A47 North Tuddenham to Easton

Volume 9 **9.8 Applicant's Response to the** **Written Representations**

A47 North Tuddenham to Easton
Development Consent Order 202[x]

**9.8 APPLICANT'S RESPONSE TO THE
WRITTEN REPRESENTATIONS**

- HE551489-GTY-LLO-000-SK-BL-30001
- HE551489-GTY-LLO-000-SK-BL-30002

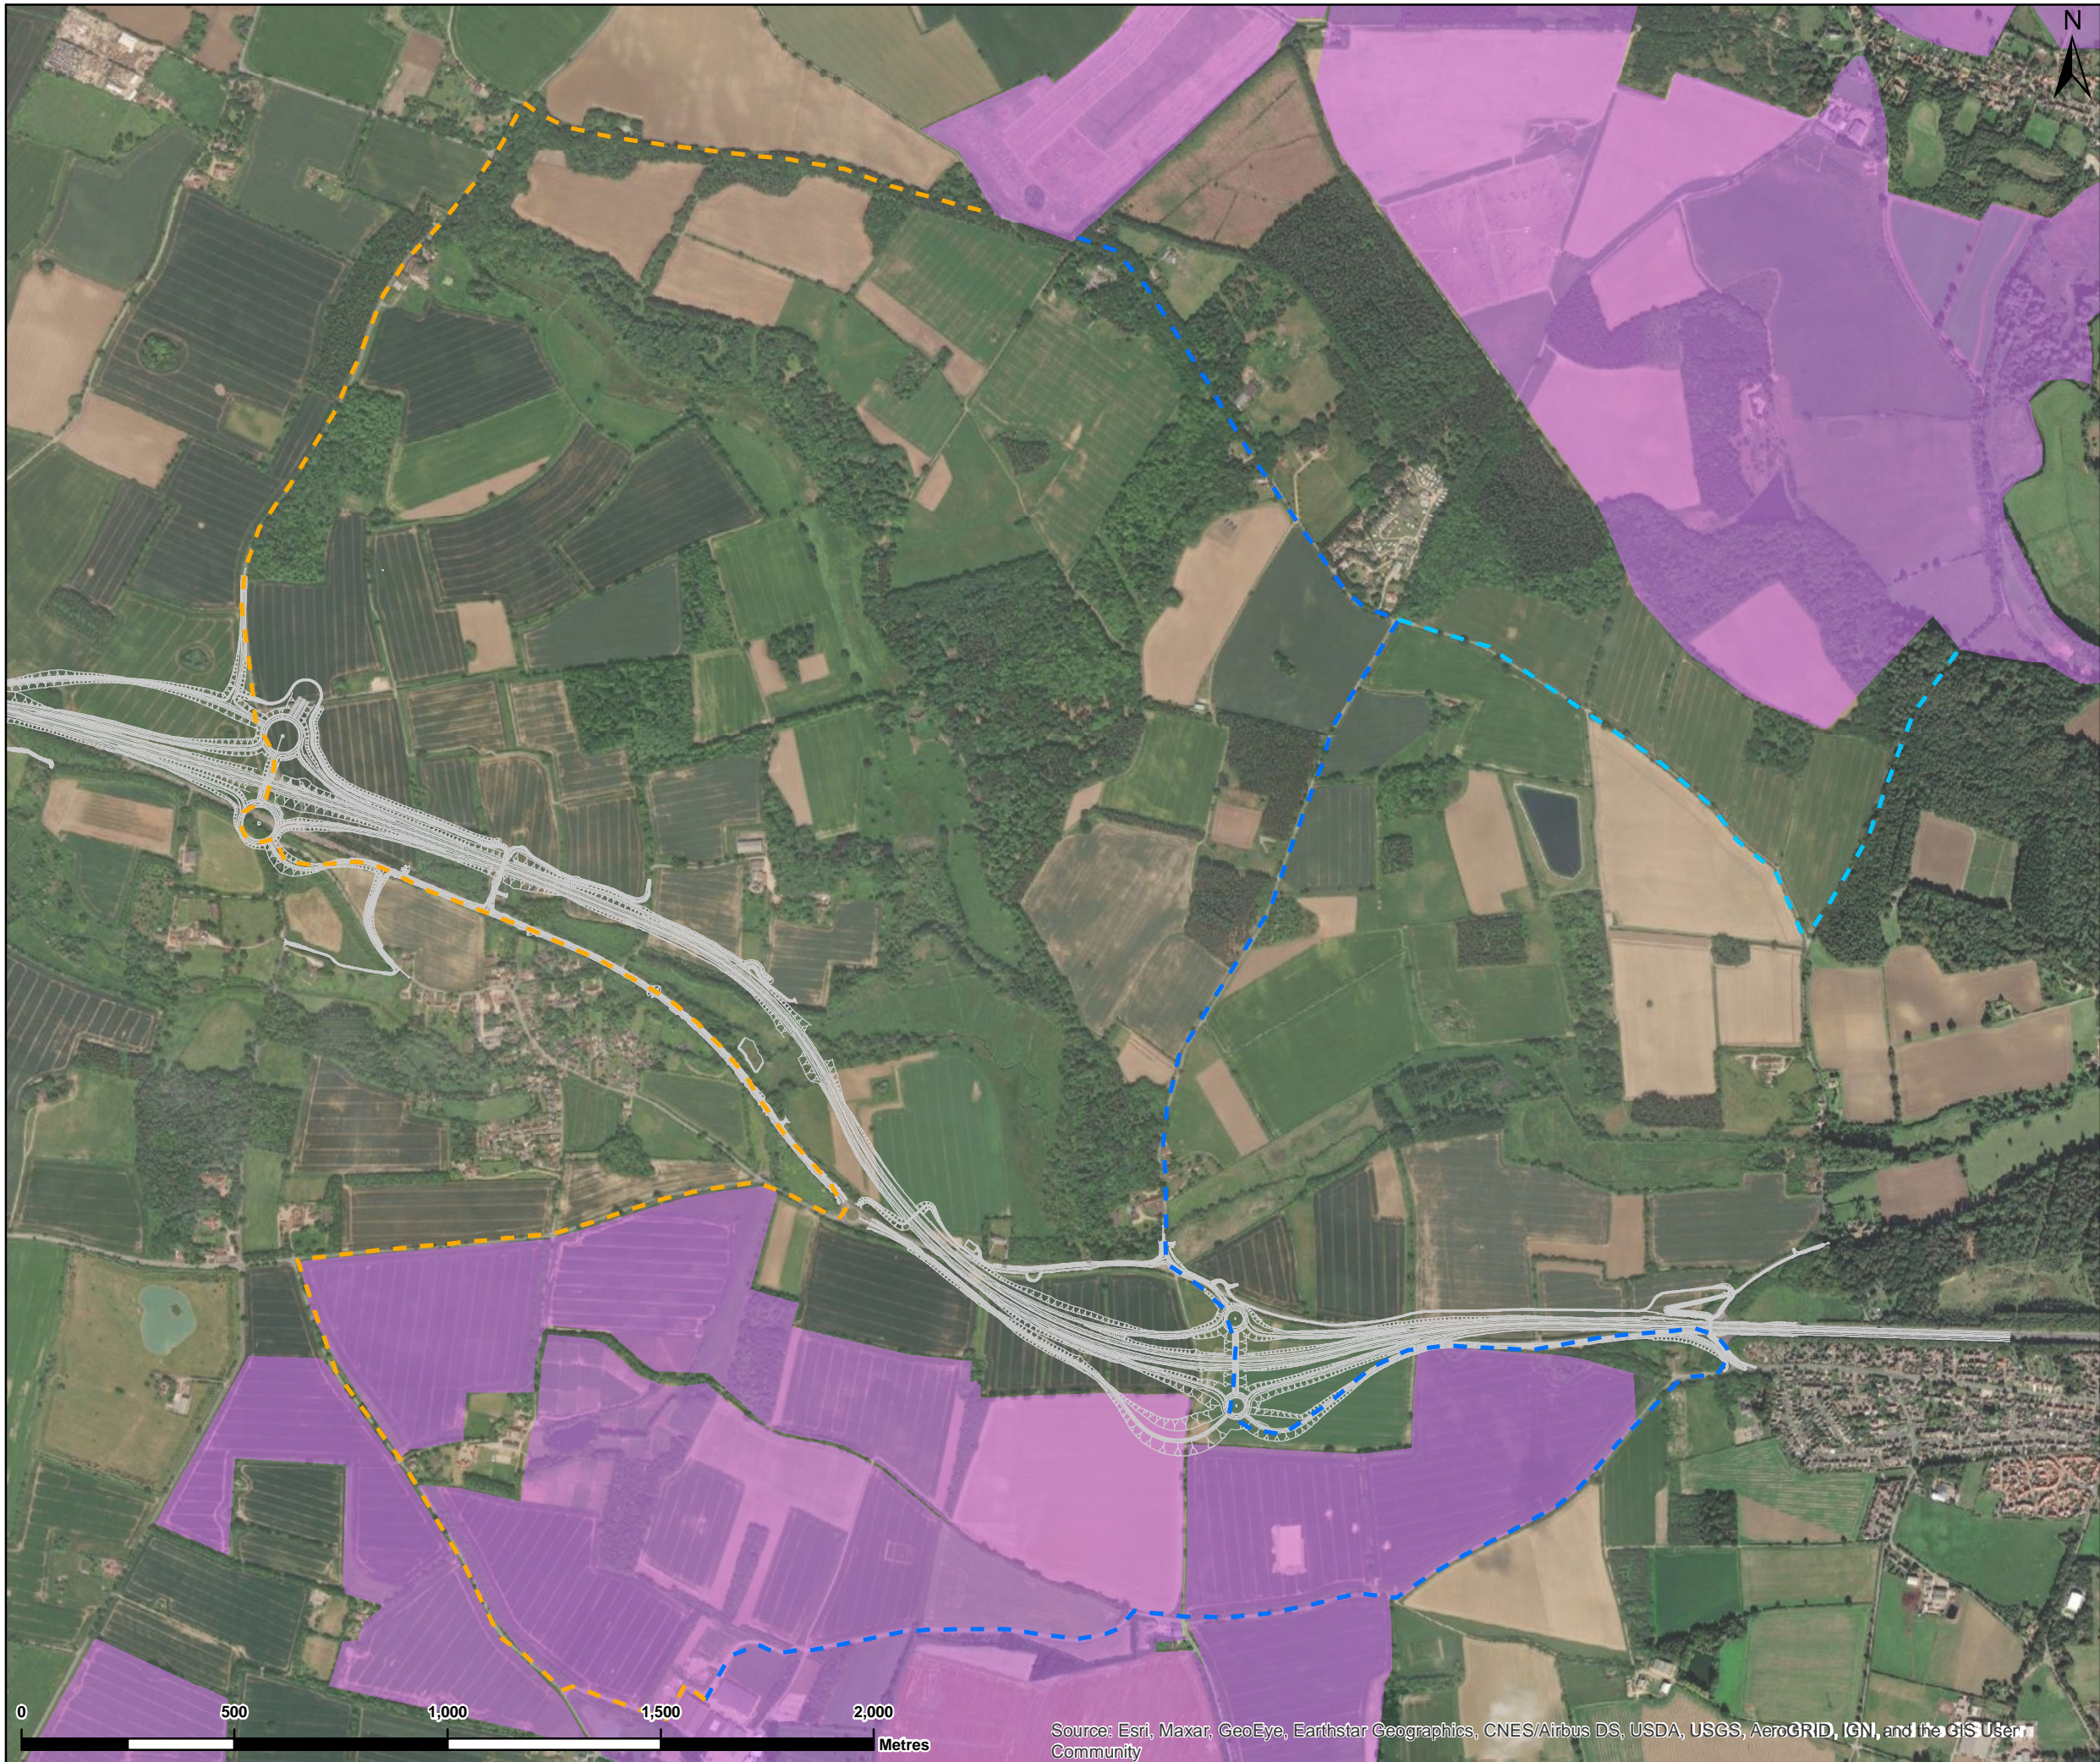
<ul style="list-style-type: none"> • Routes that will put all farm traffic through the centre of Ringland Village 	<p>The proposed routes shown on drawing HE551489-GTY-LLO-000-SK-BL-30002, in Annex A, do not indicate traffic entering the centre of Ringland Village.</p>
<ul style="list-style-type: none"> • Routes that will put all farm traffic through Ringland Hills 	<p>The proposed routes shown on drawing HE551489-GTY-LLO-000-SK-BL-30002, in Annex A, do not place all traffic through Ringland Hills.</p>
<ul style="list-style-type: none"> • Farm traffic to be pushed to the village Easton straight past the historic Church and near the proposed developments and interacting with FEP traffic. 	<p>The LDO made by Broadland District Council (BDC) on 31 October 2017 required a vehicular access route to the Food Enterprise Park to be approved prior to commencement of development pursuant to condition 2.20. The route via Church Lane was approved by BDC on 21 December 2018 and has therefore been the intended route since that date. The LDO also requires the closure of Blind Lane upon completion of 10,000m² of development floorspace. So the closure of Blind Lane and any associated impacts are likely to occur regardless of whether the Scheme is implemented. _-</p> <p>As set out in RR-074.2 of the Applicant's Responses to Relevant Representations (REP1-013), the Applicant notes that the promoters of the FEZ and owners of Honingham Thorpe Farm (HTF) have now lodged a planning application (27th July 2021) with the Local Planning Authority, Broadland District Council, (Application No.: 20211335) for the provision of a private access to the Scheme along the route of the existing Blind Lane access.</p> <p>The Applicant will continue to engage on this matter through the course of the DCO Examination in light of the submitted planning application.</p>
